Access Compliance Report

Public Rights-of-Way

(Curb Ramps)

Intersection ID: 6887	Main Street: W_SUGAR_CREEK_RD	Cross Street: WALES_ST	Location: W
ADA ID: 3B7E31F965EE	Ramp Type: BlendTrans1	Initial Pass/Fail: Fail	Overall Compliance: No
			Severity Score: 10

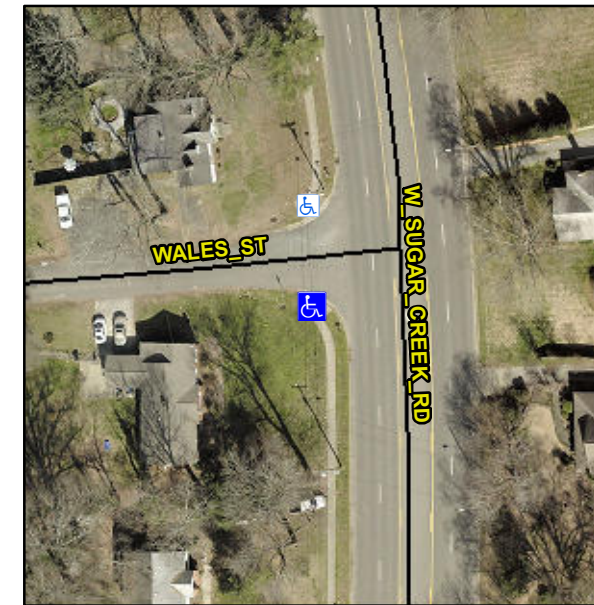
NO RT SW

Not Found, R304.5.1, R304.5.3

Compliance	Description	Data	Compliance	Description	Data
N/A	Ramp Length (in)	75.0	Yes	BlendTrans Slope (%)	4.9
No	Ramp Width (in)	38.0	No	BlendTrans XSlope (%)	3.1
N/A	Flare Type LT	N/A	N/A	Flare Type RT	N/A
N/A	Flare Slope LT (%)	N/A	N/A	Flare Slope RT (%)	N/A
N/A	Flare Traversable LT?	N/A	N/A	Flare Traversable RT?	N/A
N/A	Landing Length (in)	N/A	N/A	DWS Provided?	N/A
N/A	Landing Width (in)	N/A	N/A	DWS Contrast?	N/A
N/A	Landing Slope (%)	N/A	N/A	DWS Length (in)	N/A
N/A	Landing X Slope (%)	N/A	N/A	DWS Full Width?	N/A
N/A	Landing Curb? (Y/N)	N/A	N/A	DWS Offset (in)	N/A
N/A	Shared Landing?	N/A			
N/A	Gutter Ponding?	N/A	N/A	Gutter Slope (%)	N/A
N/A	Gutter Lip Ht (in)	N/A	N/A	Gutter X Slope (%)	N/A
N/A	Painted X Walk1?	No	N/A	Painted X Walk2?	N/A
	X Walk 1 Direction	To N		X Walk 2 Direction	N/A
	X Walk 1 Width (in)	N/A		X Walk 2 Width (in)	N/A
	X Walk 1 Slope (%)	0.4		X Walk 2 Slope (%)	N/A
	X Walk 1 X Slope (%)	1.3		X Walk 2 X Slope (%)	N/A

N/A	Ramp inside XWalk1?	N/A	N/A	Ramp inside XWalk2?	N/A
	Road Slope (%)	1.3		Clear Space?	N/A
	Road X Slope (%)	0.4	N/A	Clear Space to XWalk (in)	N/A
N/A	Any Obstructions?	N/A	N/A	Storm Grate/Utility Hazard?	N/A
	Obstruction Type			Storm Grate/Utility Type	
		N/A			N/A
			Yes	Surface Condition? (G/P)	Good
			No	Curb Slope (%)	23.8

Remove & Replace Curb Ramp With Two New Directional Ramps or Equivalent.
